2. To: (Receiving Organization) SST Retrieval Projects		3. From: (Originating Organization) SST Retrieval Projects		4. Related EDT No.: 406549	
5. Proj./Prog./Dept./Div.: W-320 / 8C620		6. Design Authority/ Design Agent/Cog. Engr.: J.W. Bailey/J. R. Bellomy		7. Purchase Order No.: N/A	
8. Originator Remarks: Supporting Document Approval and Initial Release				9. Equip./Component No.: AY-Farm Electrical	
				10. System/Bldg./Facility: 241-C-106	
11. Receiver Remarks: 11A. Design Baseline Document? <input type="checkbox"/> Yes <input checked="" type="checkbox"/> No				12. Major Assm. Dwg. No.: H-2-818693	
				13. Permit/Permit Application No.: N/A	
				14. Required Response Date: N/A

# PROJECT W-320 ACCEPTANCE TEST REPORT FOR AY-FARM ELECTRICAL DISTRIBUTION

Abstract: Project W-320 Acceptance Test Report for AY-Farm Electrical Distribution

5. H-2-818699, SH 1:

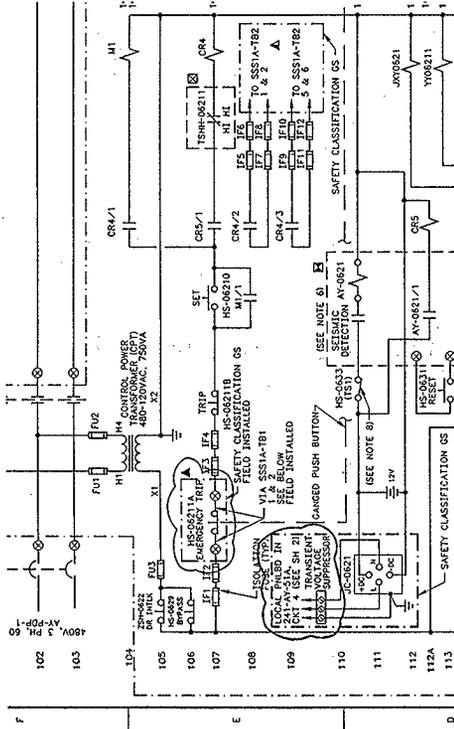
- a. Zone D/E-3/7: Revise text in specified columns for wire runs #-22, #-23, #-34 & #-35, and add wire run #-34A as shown below:

WIRE RUN NO	NO OF WIRES	SIZE OF WIRES	TYPE OF WIRES	FROM	VIA	TO	WIRE NUMBERS
#-22						241-AY-51A (LOCAL PANEL)	
#-23						241-AY-51B (LOCAL PANEL)	
#-34				241-AY-51A LOCAL PANEL CKT 4	NIPPLE	TRANSIENT VOLTAGE SUPPRESSOR	CKT 4-H, -N, -GND
#-34A	2	#12	7	TRANSIENT VOLTAGE SUPPRESSOR	*-3P32	AY-SSS-1A TB1 (BATTERY CHARGER)	CKT 4-H, -N, -GND
#-35				241-AY-51B LOCAL PANEL CKT 4		AY-SSS-1B TB1 (BATTERY CHARGER)	CKT 4-H, -N, -GND

HNF-SD-W320-ATR-007, Rev. 0  
ENLARGED PL  
H-2-818695 SH. 1 SCALE: 1

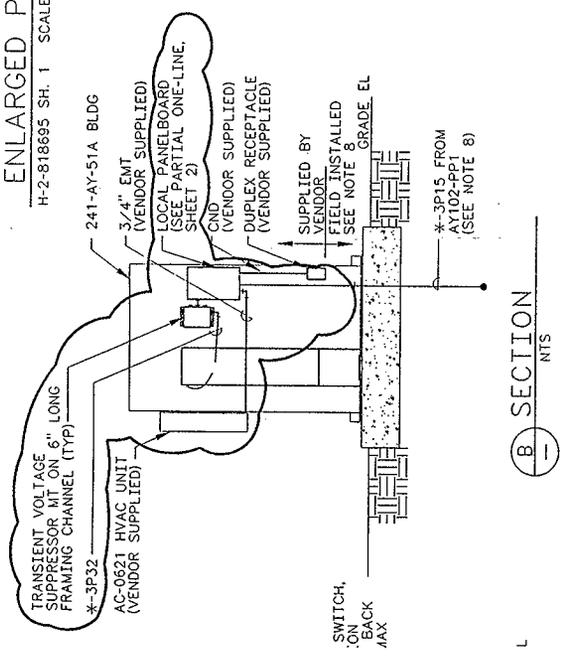
**TRANSIENT VOLTAGE SUPPRESSOR INSTALLATION**  
**CONSTRUCTION NOTE: (DO NOT INCORPORATE ON DRAWING)**
